Project **Brownsbarn Site N7 Landscape Design**

Title **Landscape Masterplan for**

Drawn: CZ	03/02/2022	Designed: CZ	12/01/2022
Checked: CP	03/02/2022	Approved: BOC	03/02/2022
Project Reference: 2020s1431		Scale: As Shown @ A1	
Drawing Number: ENO-JBAI-XX-DR-L-0002	Status: A3	Revision: C06	Sheet Size: A1

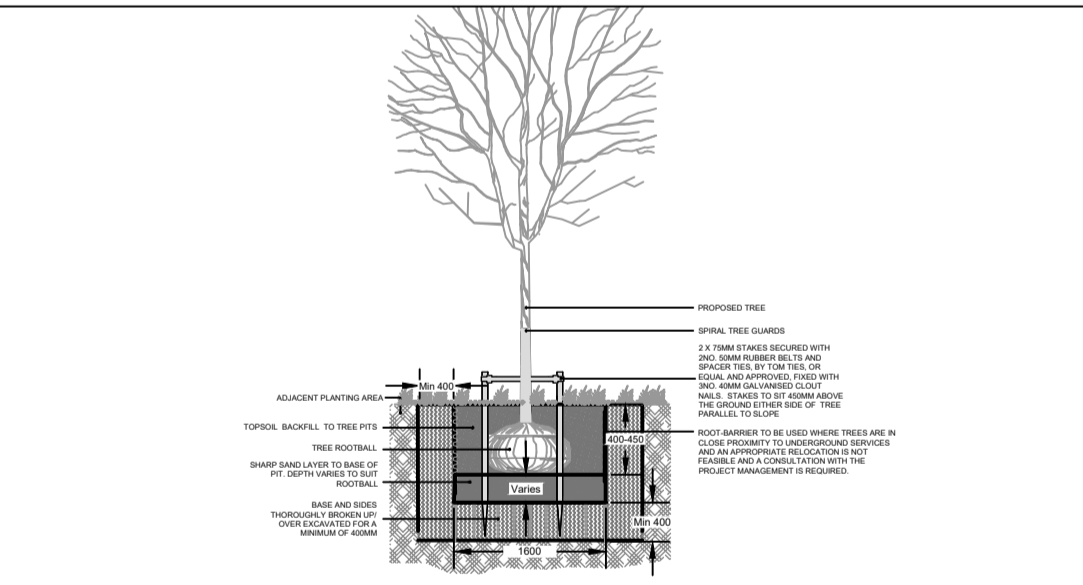
- Regarding RFI item 3, along the western boundary, the 10m buffer zone has been increased to provide a buffer of between 15.1m and 25m. No tree removal required from the development. More planting has been added along the western boundary to supplement existing planting and enhance the biodiversity.

- Regarding RFI item 5, a green roof has been added following the relevant recommendations. (See Landscape Masterplan, Drawing No.ENO-JABI-XX-DR-L-0002). The Masterplan and Planting Plan show increased planting along the southern boundary of site, the planting will be decreasing toward the protected structure. The Landscape Masterplan also shows permeable paving (grass-crete) throughout the site, with tree planting between the car parking space.

- A tree pit detail has been added into the carpark design which adjacent to hard standing surfaces, this will allow incorporated SuDS.
- Tree planting along the N7 has been kept close to the proposed buildings to allow for maximum retention of views from the N7 towards the *Specialized Ireland* while enhancing screening of the proposed building and provision of habitat.
